COCKLE BAY PARK
SYDNEY

Cockle Bay Park response to
submission report
Revised Architectural Report Addendum
11.08.2022

Revised Architectural Report Addendum

CG4

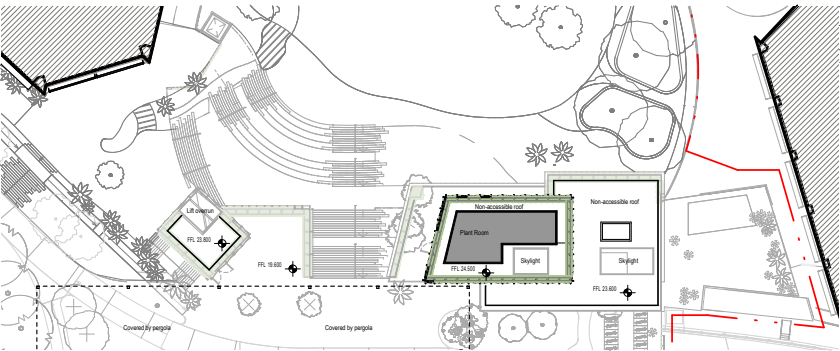
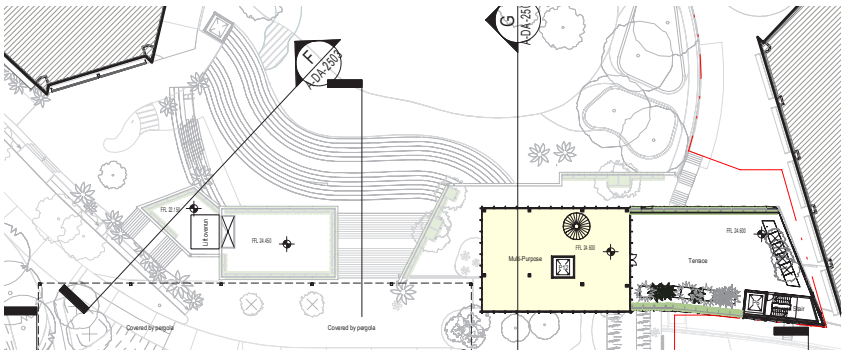
Level CG4 has been removed in order to improve the buildings massing and reduce the amount of plant rooms required on the roof.

CG3

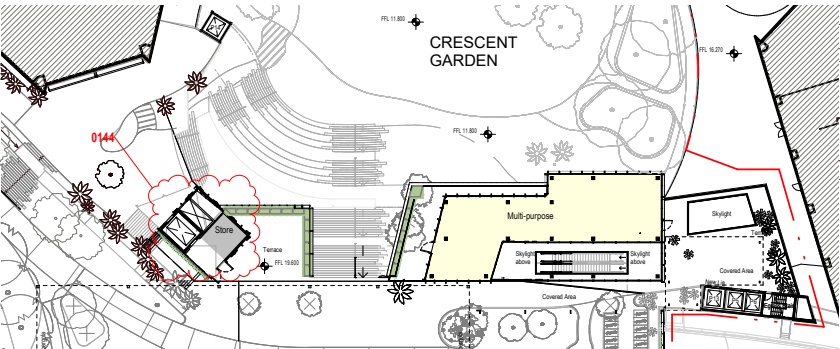
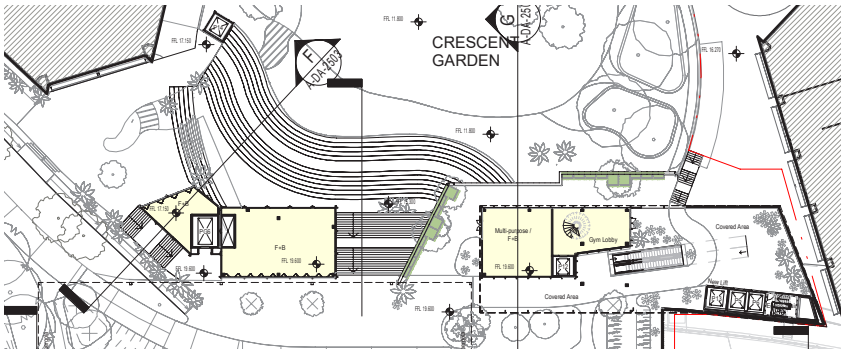
Level CG3 has been changed to a larger multipurpose space that is independent of the gym.

The small F&B unit in the north of Wellness complex has been replaced by ventilation shafts.

CG2

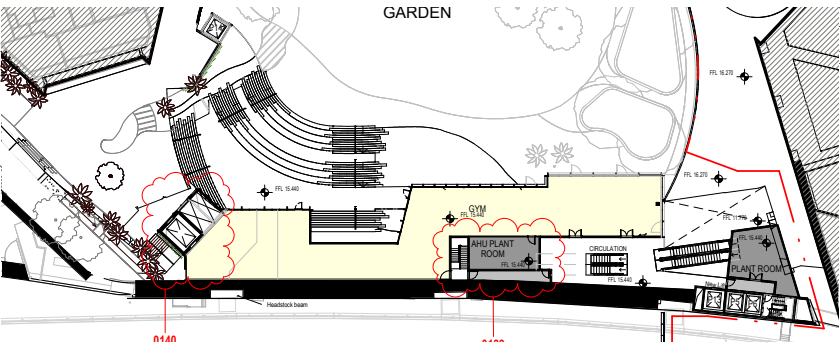
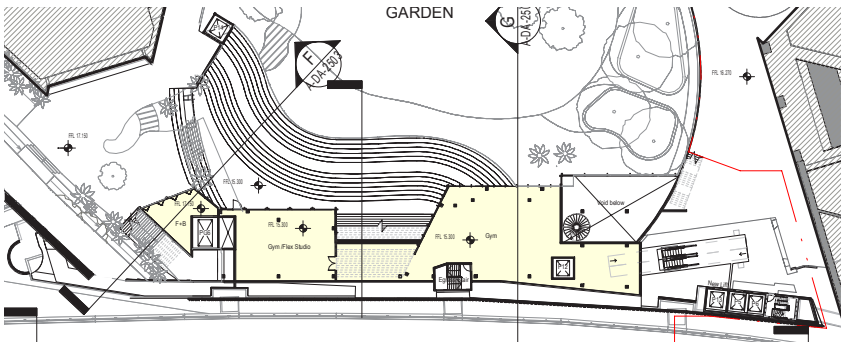
Level CG2 has been stretched southwards to allow more useable area for the gym.

CG1

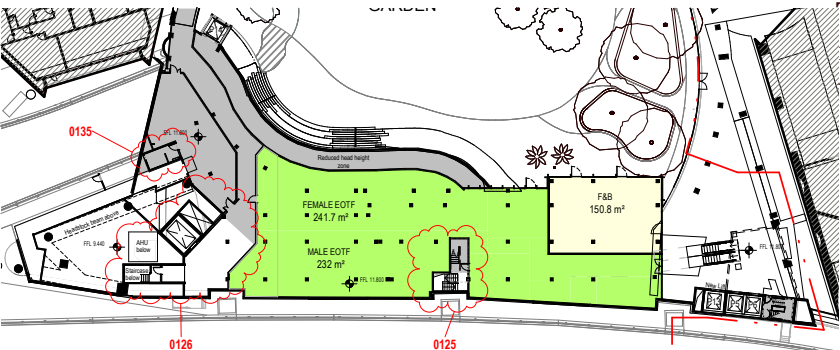
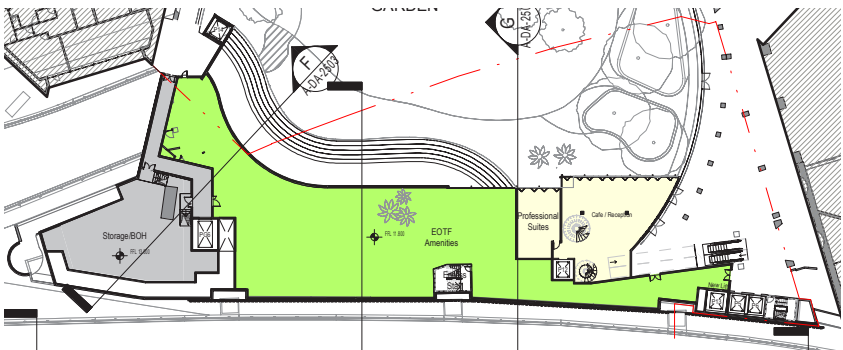
The EOTF has been compacted and streamlined to allow more area for the crescent garden maintenance room. There has been no reduction to the amount of showers or lockers in this area.

DP1

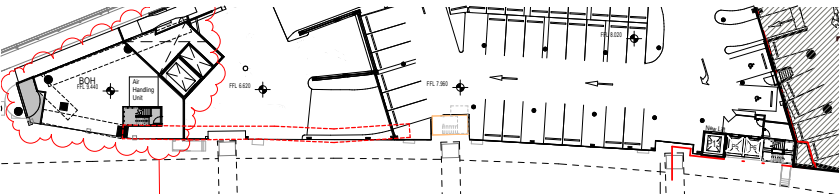
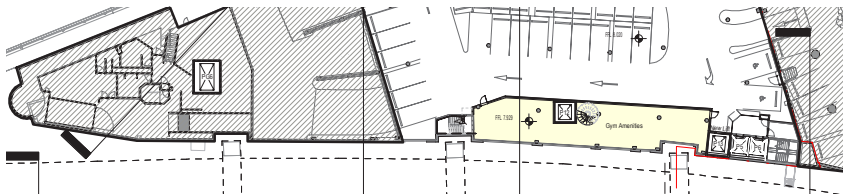
The gym changing rooms has been moved into the EOTF on CG1.

1.1.2 Land Bridge Edge Protection - Market Street/Civic Link

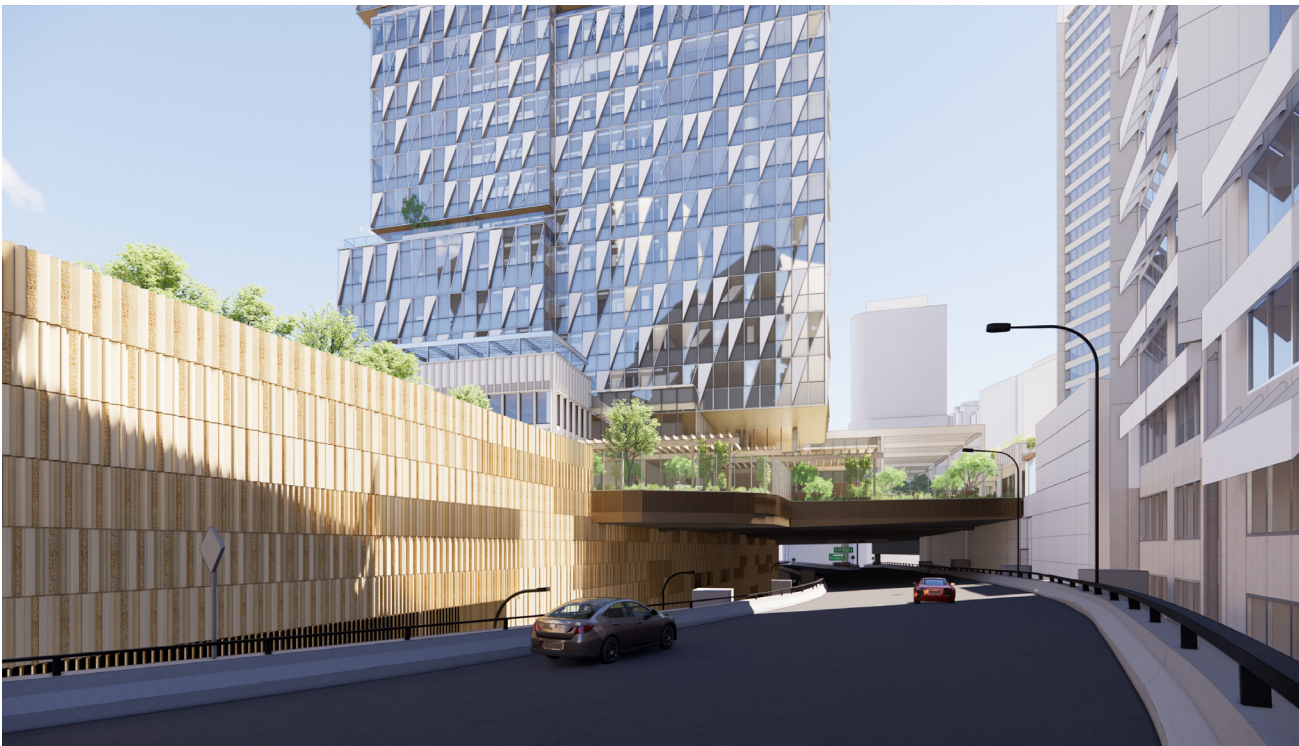
The DIP stressed after the SSDA submission that the proposed solid massing proposed for the edge protection would be better as a lightweight structure that visually connects the link with Market Street and the northern/central business district. Following these recommendations we have replaced the colored precast edge protection with open balusters along Market Street bridge and plexiglass panels above the western distributor. This in turn will make the landbridge park visible from the top of Market street and the Western Distributor.

Design Excellence - Imagery comparison

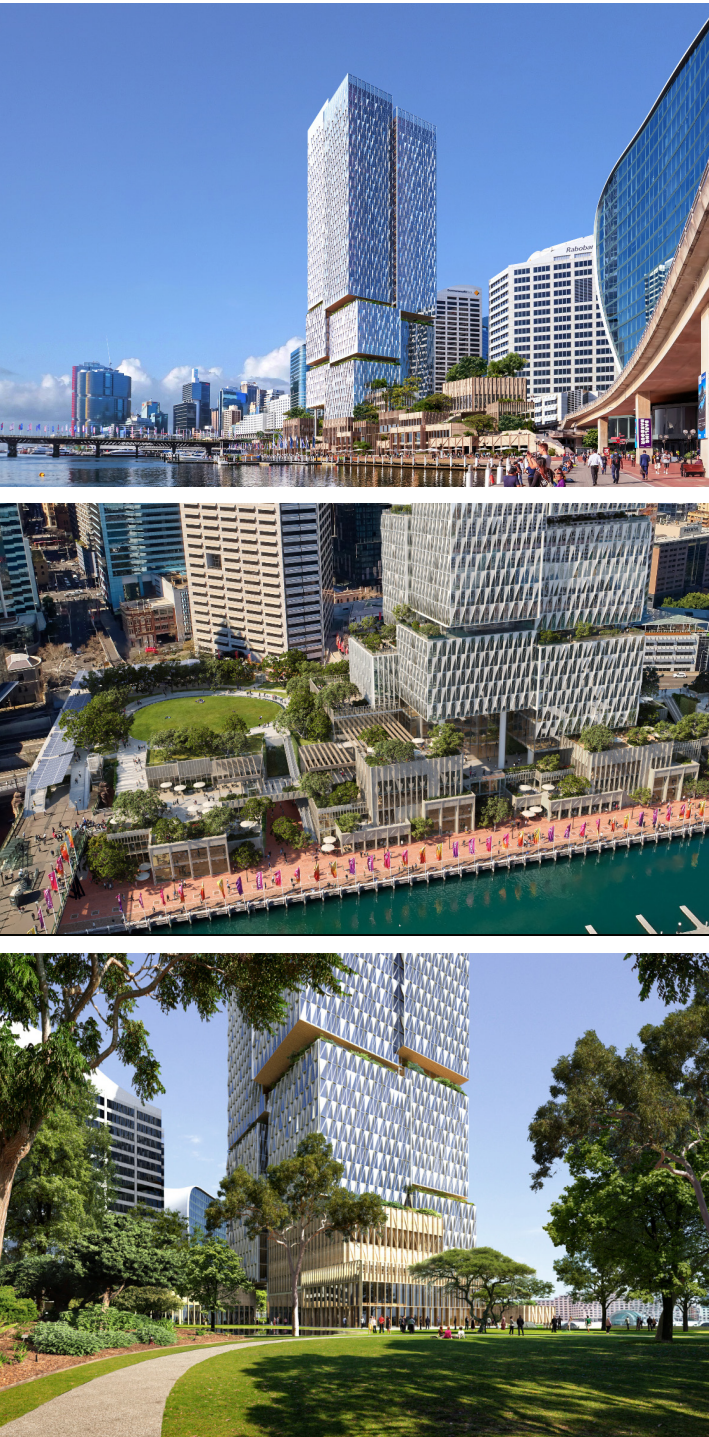
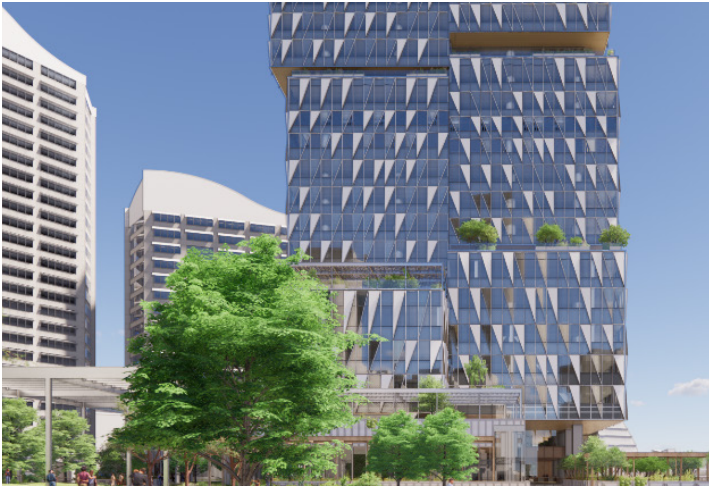
Provide the omitted Appendices (A to D) of the Design Excellence Report (EIS Appendix M) and comparative imagery of the competition winning scheme

Please refer to the attached comparative imagery.
The omitted appendices have been provided as part of the broader Response to Submissions package. Refer to Ethos Urban's Submissions and Amendment Report.

Design Excellence - Druitt Bridge

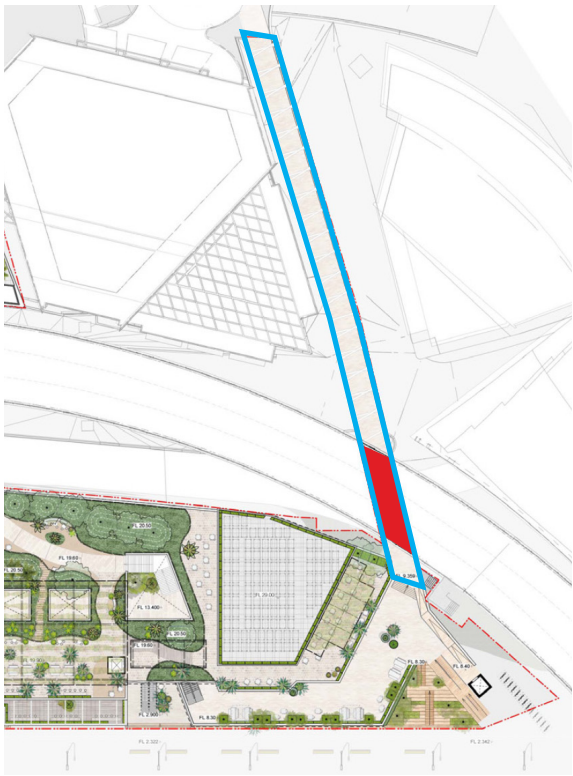
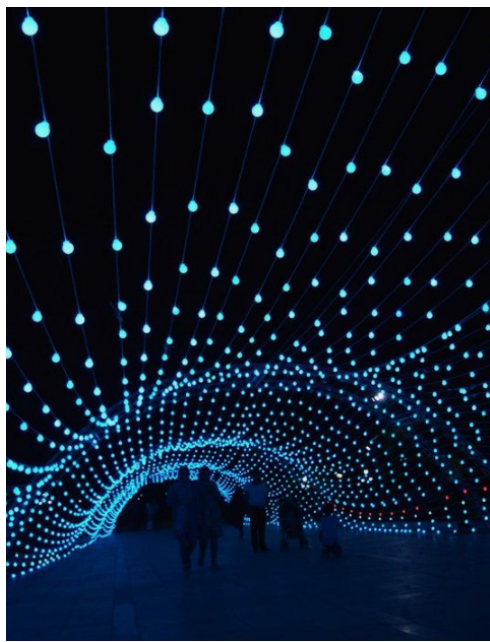
Provide a detailed response to Future Environmental Assessment Requirement (FEAR) C20 and Design Guidelines 3.9, which require investigation of improvements to the Druitt Street Bridge route, aesthetic treatments, enhanced user experience and potential increased pedestrian capacity (noting this is a DIP matter for resolution and a concern of Council).

The upcoming metro station is not expected to put any further pressure on Druitt St Connection, as the commuters are usually choosing the shortest path to their office, the approach analysis shows that the preferred route from Druitt Street into the development is from the NW corner of Druitt and Sussex Streets through the existing Darling Park Towers.

Moreover, we are unable to increase pedestrian capacity due to the bridge's location above and below the western distributor. It also should be noted that the bridge has sufficient pedestrian capacity, clear width, for today's pedestrian traffic and that for when the project is complete.

Henning Larsen plans on improving the Druitt Street Bridge route, aesthetic and user experience by doing a number of light interventions. We would like the bridge to be repaved to facilitate equitable access (removal of cracks), add lighting as to remove dark zones along its path to create sense of security for users, and lastly commission a local artist to create an art piece on the underside of the western distributor directly above Druitt Street bridge to animate the crossing experience consistent with the Public Art Strategy prepared by Cultural Capital.
